ADDENDUM NO. 1  
PUBLIC WORKS ADDITIONS  
CITY OF PARAGOULD  
PARAGOULD, ARKANSAS  
Project No. 23044

September 5, 2024

The proposed Contract Documents, dated August 16, 2024, have been modified as follows:

1 SECTION BUILDING A  
A4.1 1/8" = 1'-0"

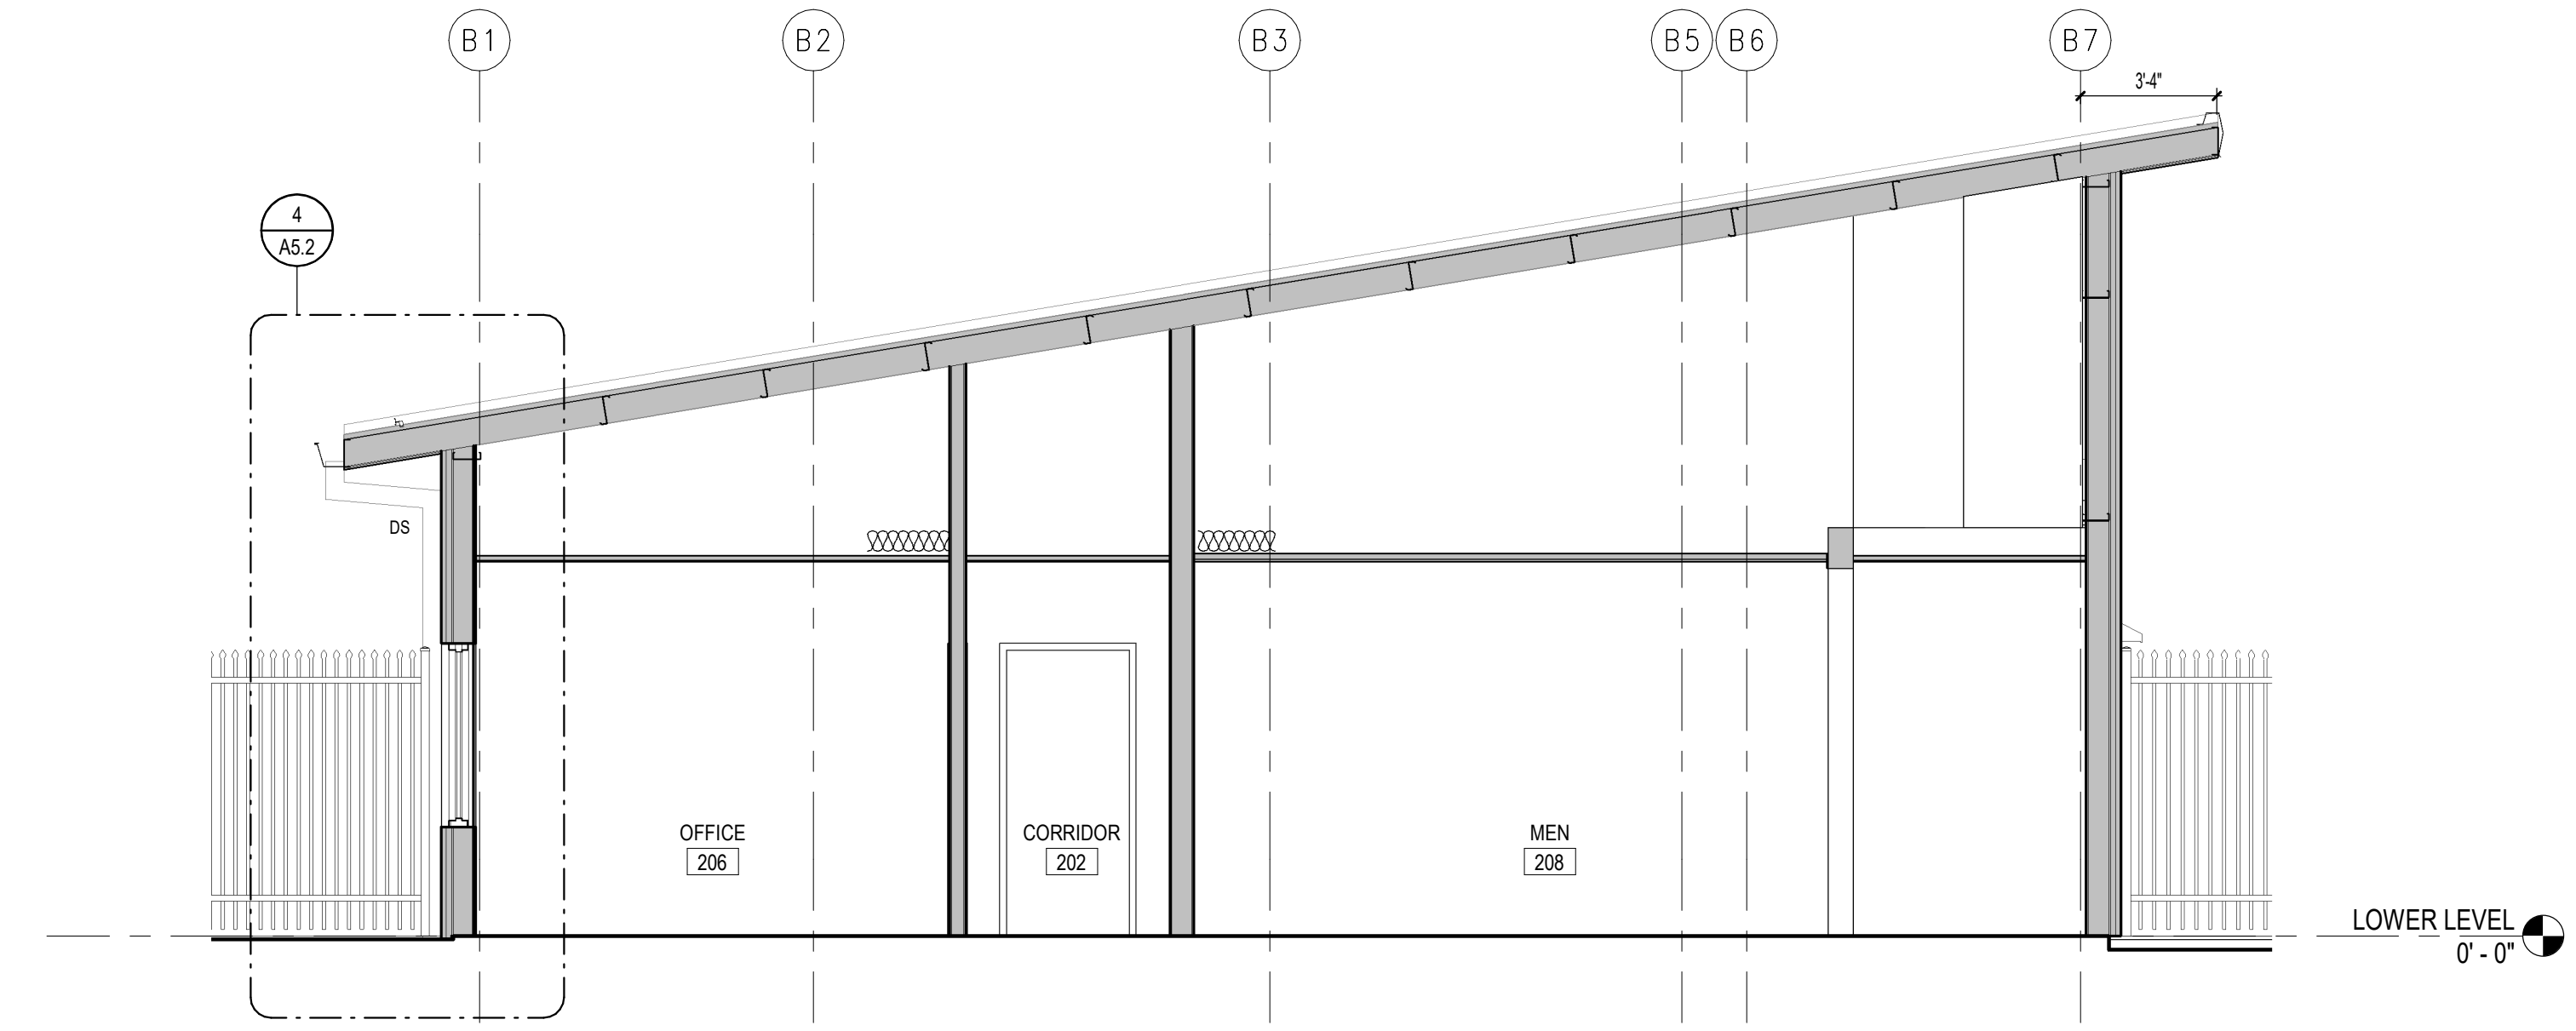
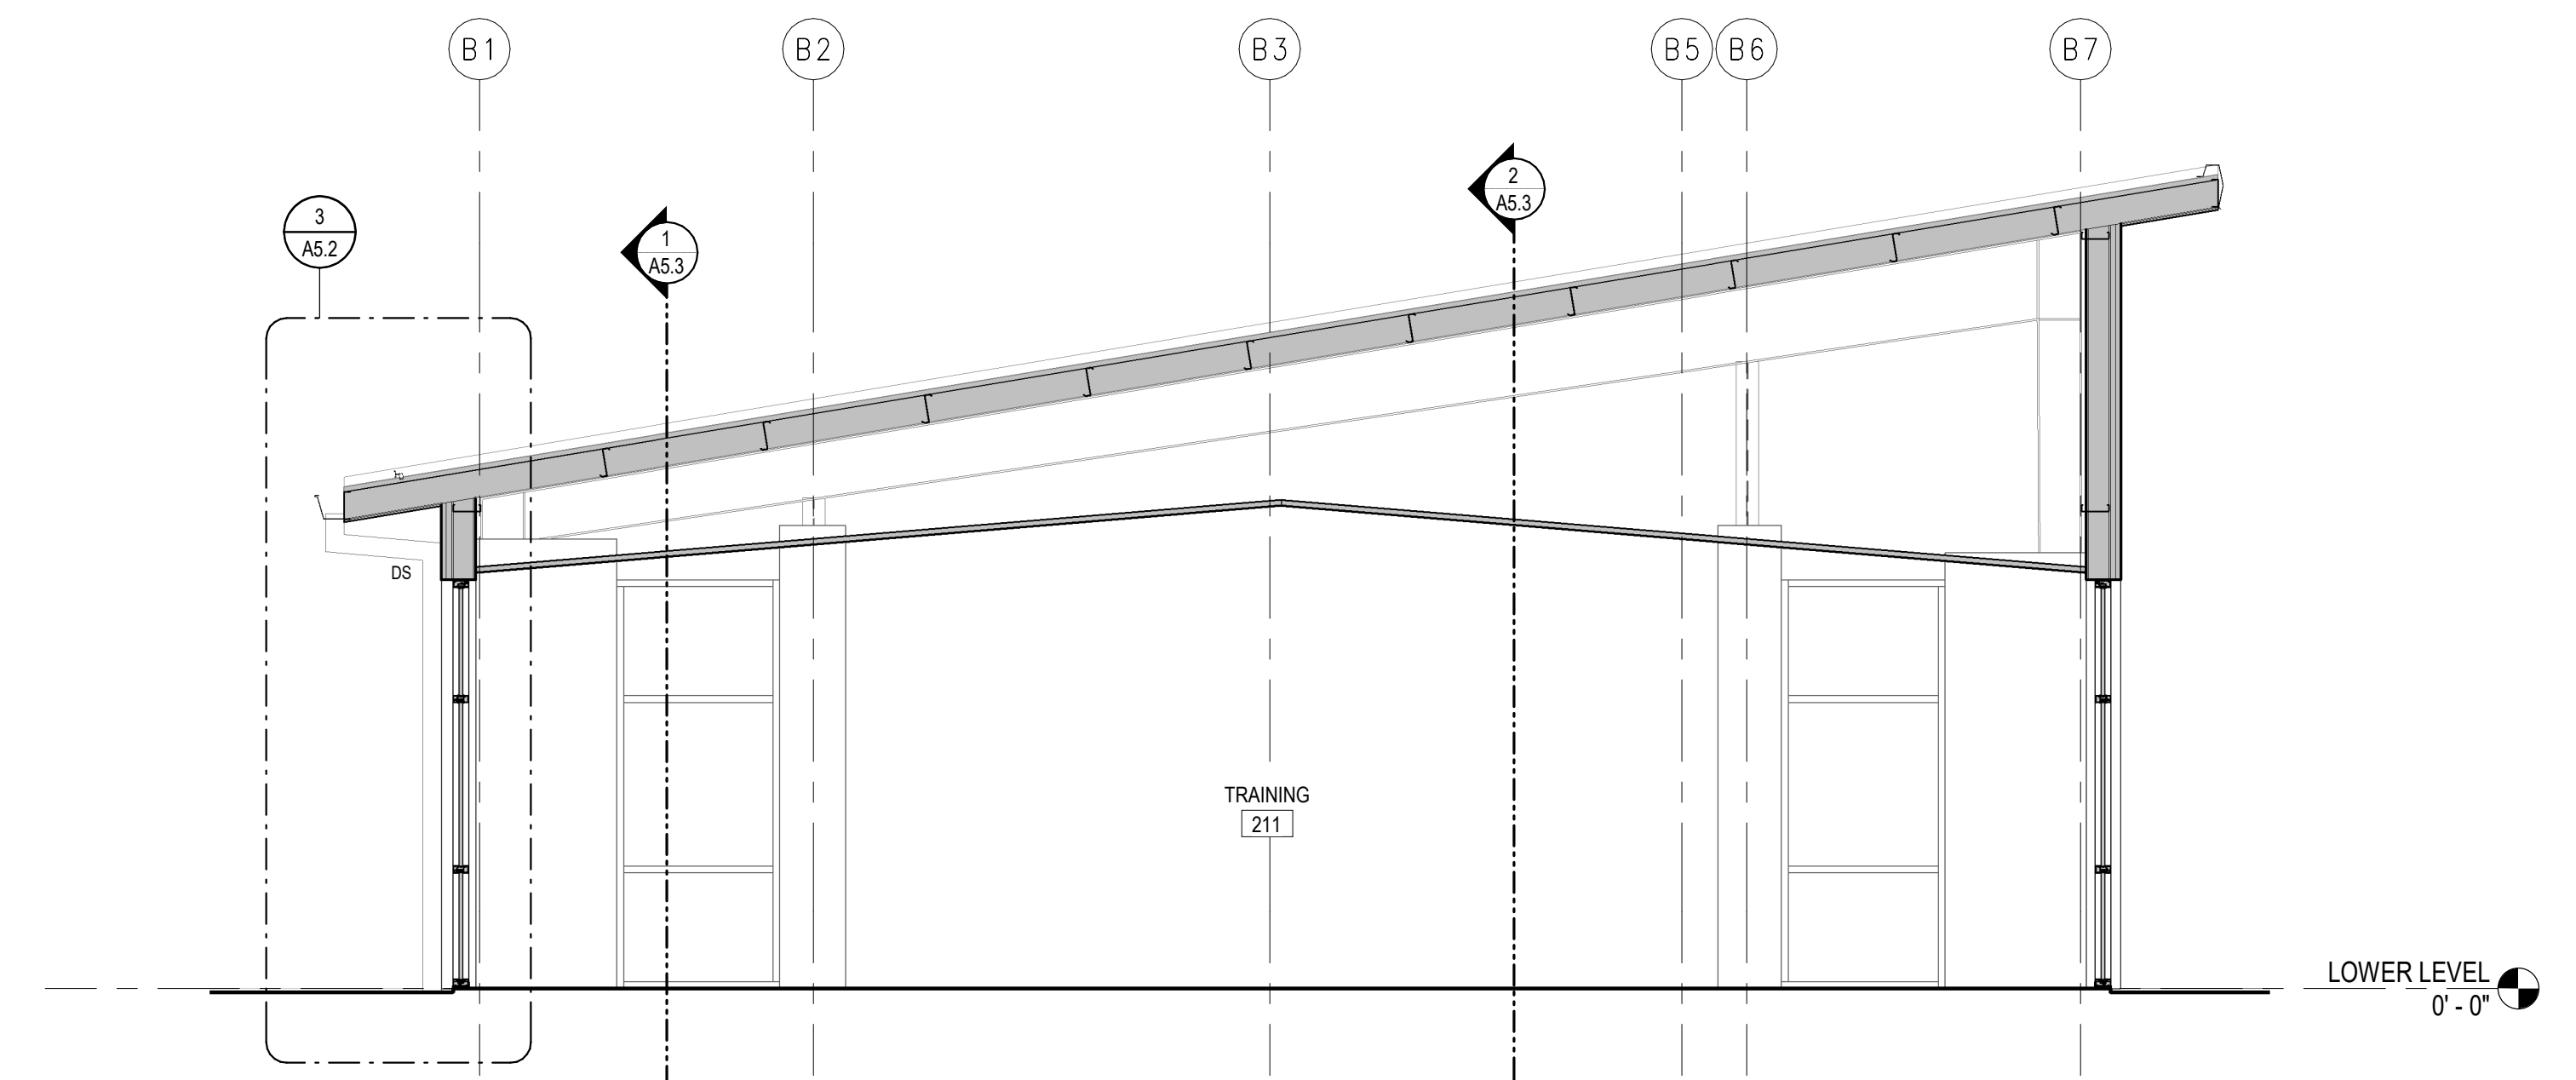
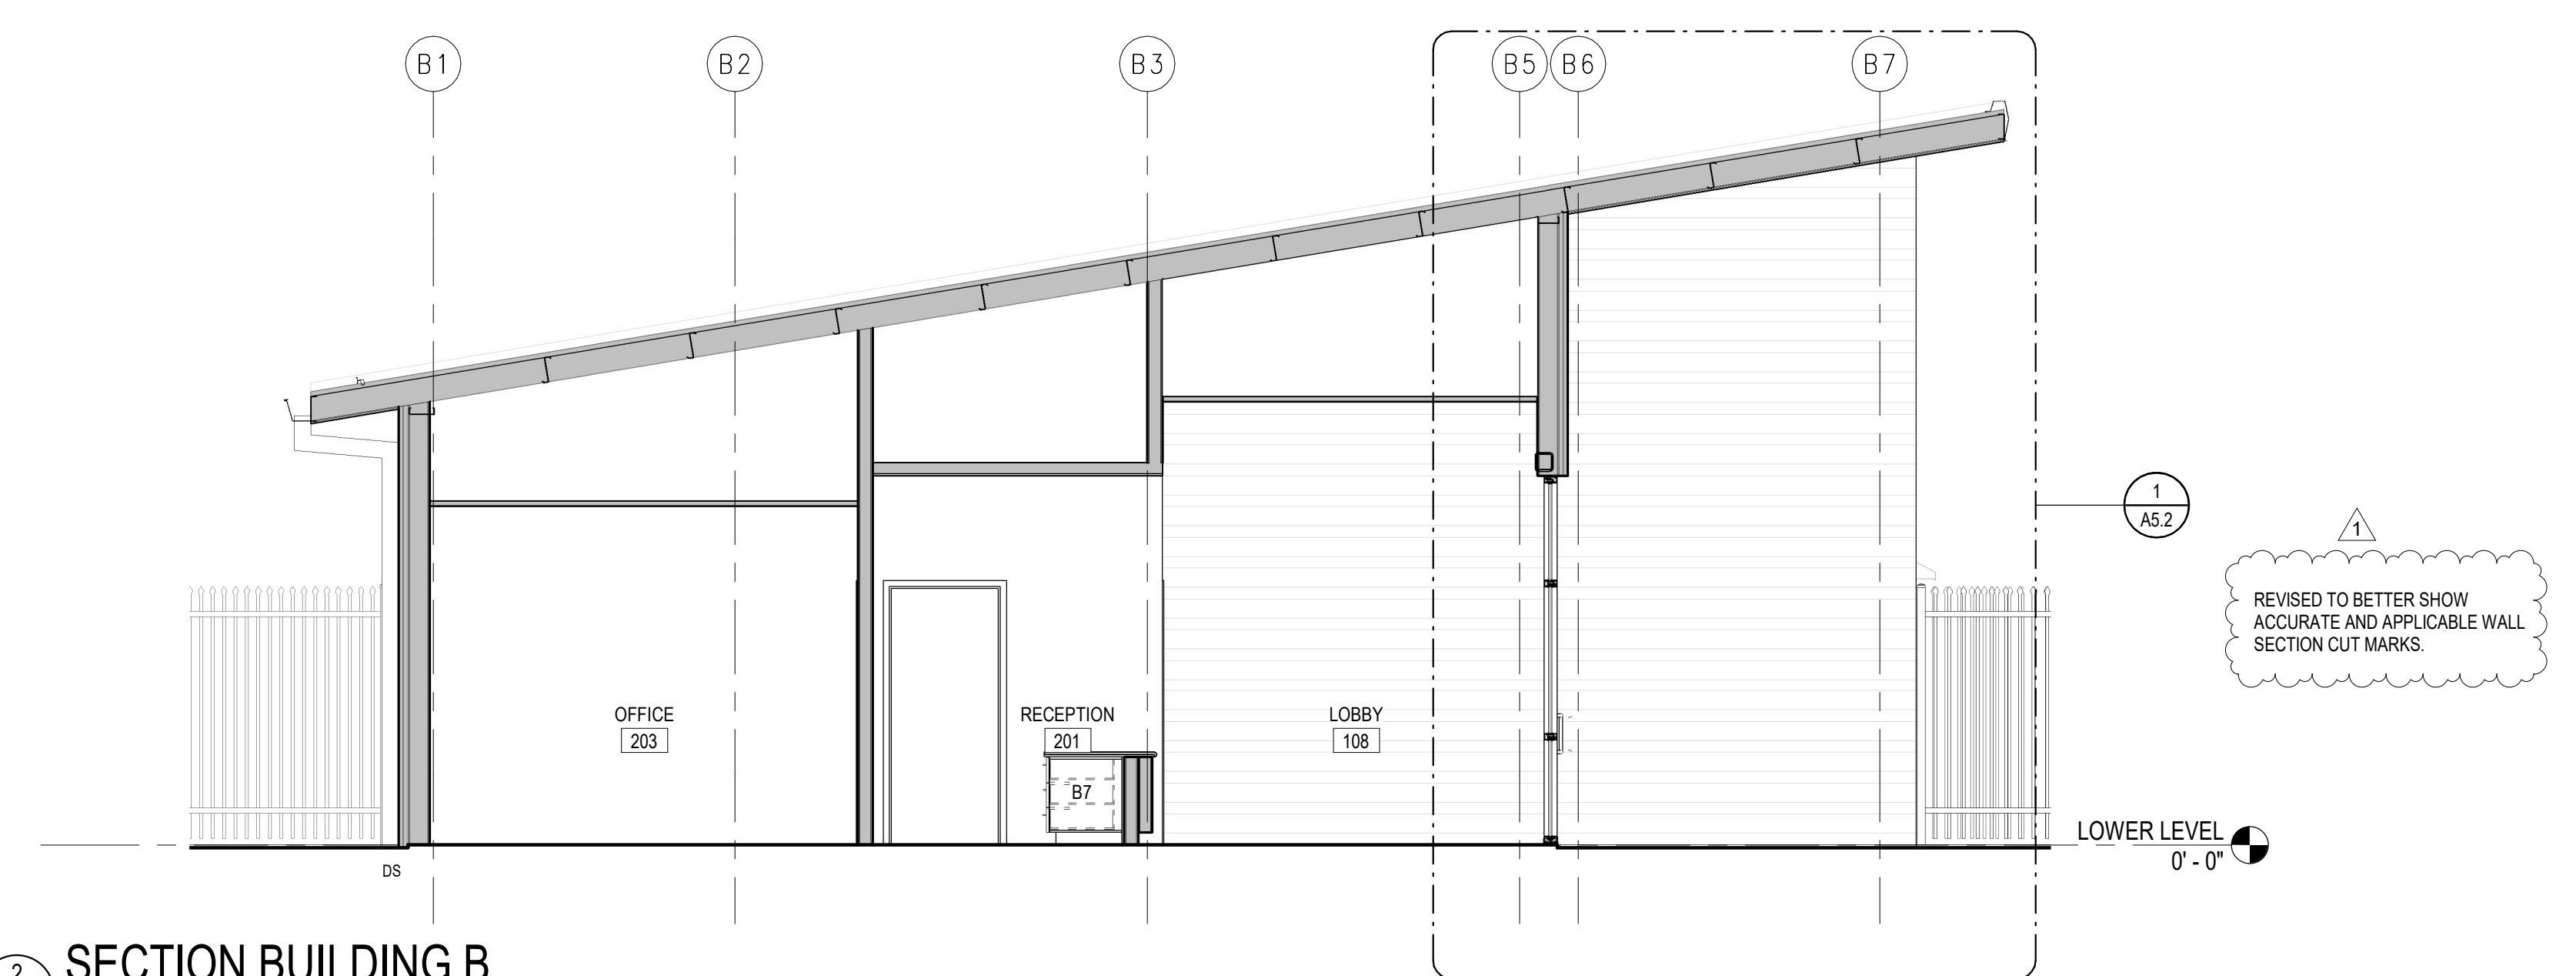
- Item #7: Sheet A4.1, Revised 2024 09-05 (attached): Revised to better show accurate and applicable wall section cut marks.
- Item #8: Sheet A8.1, Door Schedule: Door 104.1 shall be 3'-0" in width.
